World Forum for Harmonization of Vehicle Regulations**Working Party on General Safety Provisions****128th session**

Geneva, 7-11 October 2024

UN Regulation No. 73 (Lateral Protection Devices)**Proposal for the 02 Series of Amendments to UN Regulation
No. 73 (Lateral Protection Devices)****Submitted by the expert from Japan ***

Figure 1

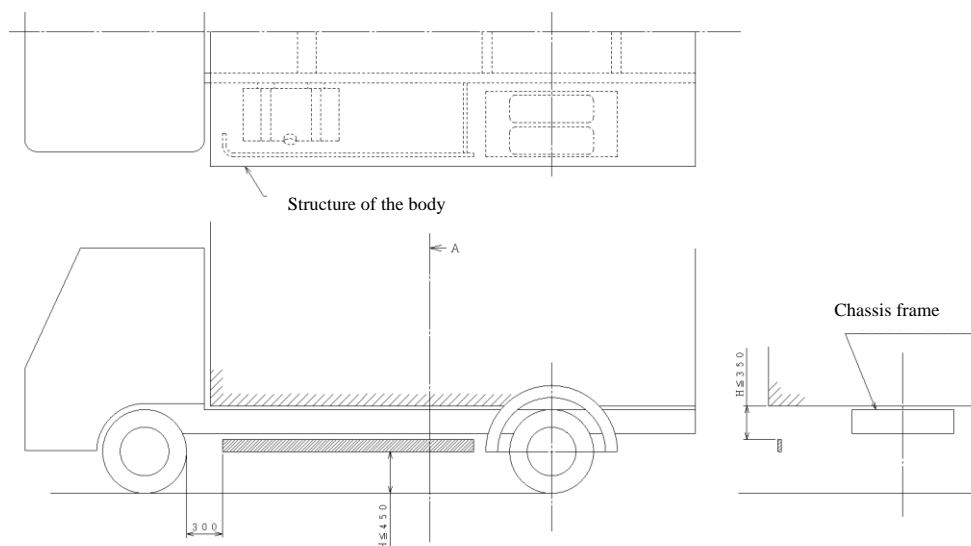
"12.9. The upper edge of LPD shall not be more than 350 mm below that part of the structure of the vehicle, cut or contacted by a vertical plane tangential to the outer surface of the tyres, excluding any bulging close to the ground (see **Figure 1 below**), except in the following cases:

"15.7. The upper edge of LPD shall not be more than 350 mm below that part of the structure of the vehicle, cut or contacted by a vertical plane tangential to the outer surface of the tyres, excluding any bulging close to the ground (see **Figure 1**), except in the following cases:

Figure 2

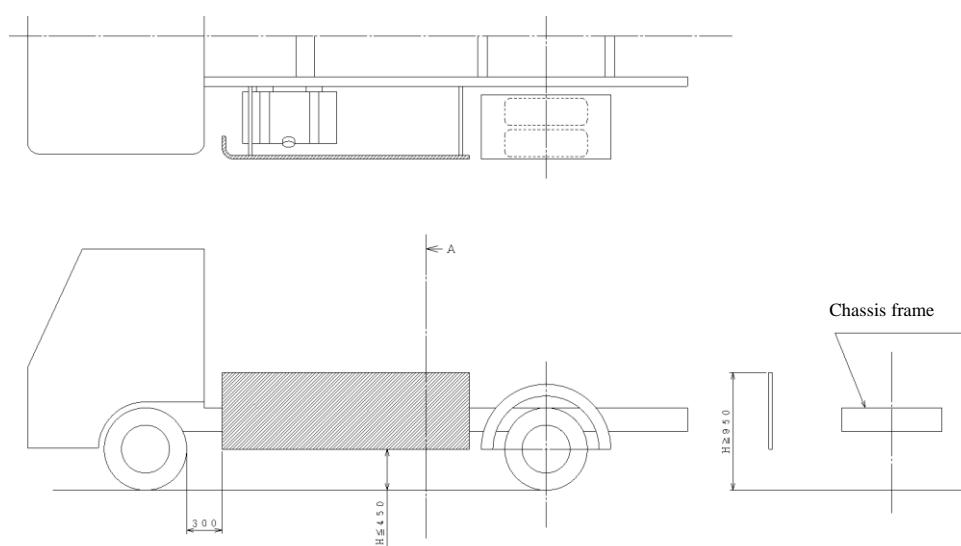
12.9.1. Where the plane in paragraph 12.9. does not cut the structure of the vehicle **or cuts the structure of the vehicle at a level more than 1.3 m above the ground, then the upper edge shall not be less than, then the upper edge shall be level with the surface of the load carrying platform, or 950 mm above the ground (see Figure 2 below);**

15.7.1. Where the plane in paragraph 15.7. does not cut the structure of the vehicle **or cuts the structure of the vehicle at a level more than 1.3 m above the ground, then the upper edge shall not be less than, then the upper edge shall be level with the surface of the load-carrying platform, or** 950 mm above the ground (see **Figure 2**);

Figure 3

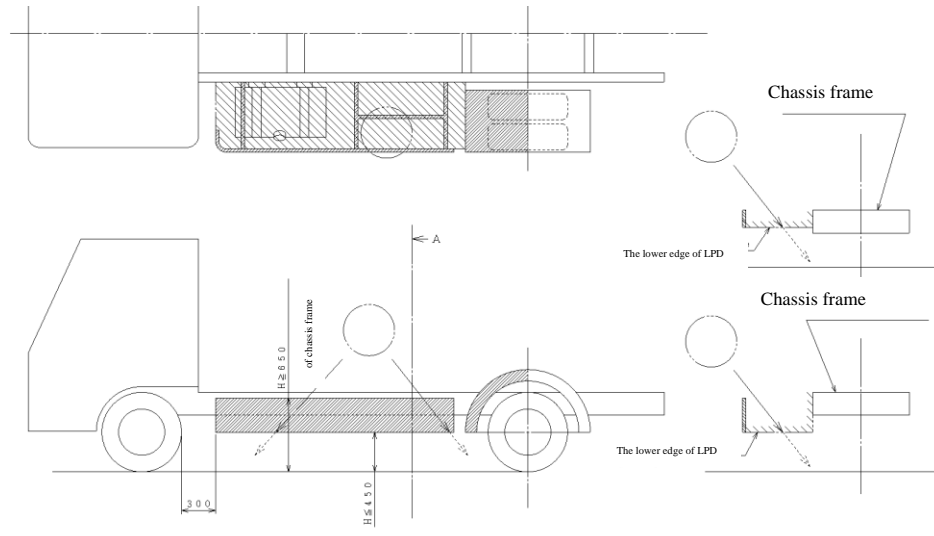
The upper edge of LPD is [650] mm above the ground, be level with the surface of the chassis frame, whichever is less, and the structure is designed to prevent cyclists from falling under the vehicle fly over the LPD (see Figure 2 below).

The fall prevention shall be demonstrated by the structure not allowing the [450] mm sphere to fall to the ground from the area enclosed by the LPD, chassis frame, and fender.

Other methods may be adopted to comply with this requirement if a manufacturer so requests. The sufficiency of the fall prevention method shall be established to the satisfaction of the Technical Service.

The upper edge of LPD is [650] mm above the ground, be level with the surface of the chassis frame, whichever is less, and the structure is designed to prevent cyclists from falling under the vehicle fly over the LPD (see Figure 3).

The fall prevention shall be demonstrated by the structure not allowing the [450] mm sphere to fall to the ground from the area enclosed by the LPD, chassis frame, and fender.
